Product Change Notification

PCN-A-1050804

Physical design of the Vehicle Dock for M9020 and M9020B has been changed.

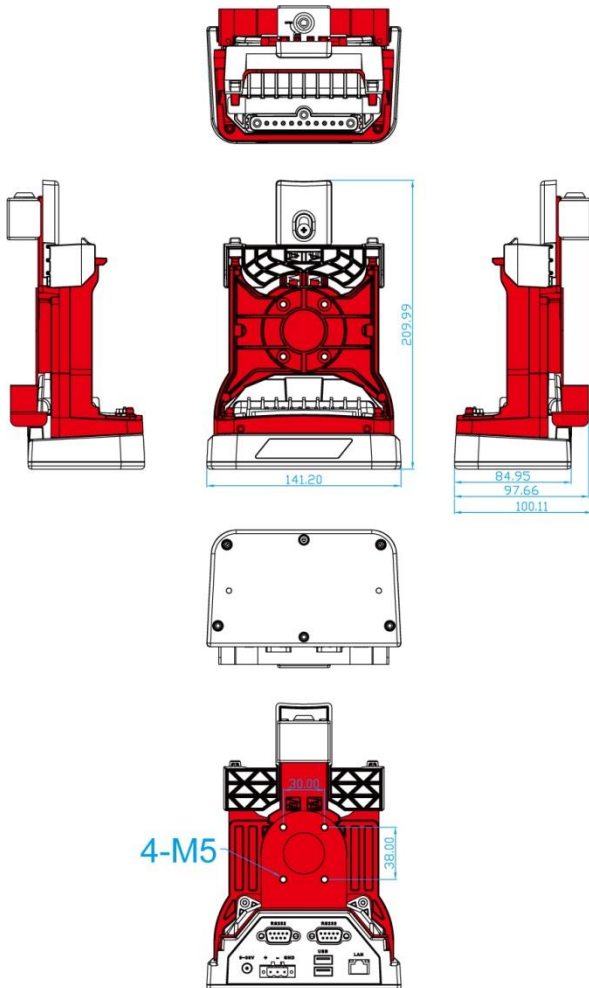
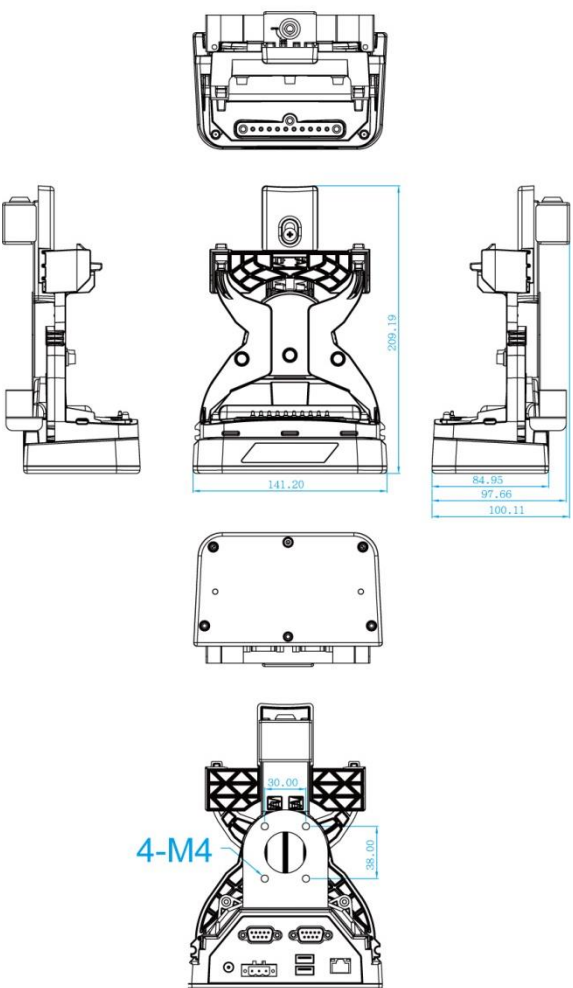
To improve the performance and reliability, the Vehicle Dock of M9020 and M9020B has been changed. The physical design of the dock has been modified, thus allowing the unit (tablet and dock) to be mounted steadily on the vehicle. The AMPS holes on the dock also have been changed from M4 screw holes to M5 screw holes and some parts of the new docking is using metal. This modification allows using the unit in a highly shock/vibration environment without getting loose.

New Vehicle Dock for M9020 and M9020B	Original Vehicle Dock for M9020 and M9020B
<p><i>line drawing of the new dock:</i></p>  <p>Improvements of the new dock:</p> <ul style="list-style-type: none"> • Metal frame on some of the parts of the dock (color in red) • M5 x 4 screw holes • USB 2.0 Connectors 	<p><i>line drawing of the old dock:</i></p>  <p>Old dock:</p> <ul style="list-style-type: none"> • M4 x 4 screw holes • USB 1.1 Connectors
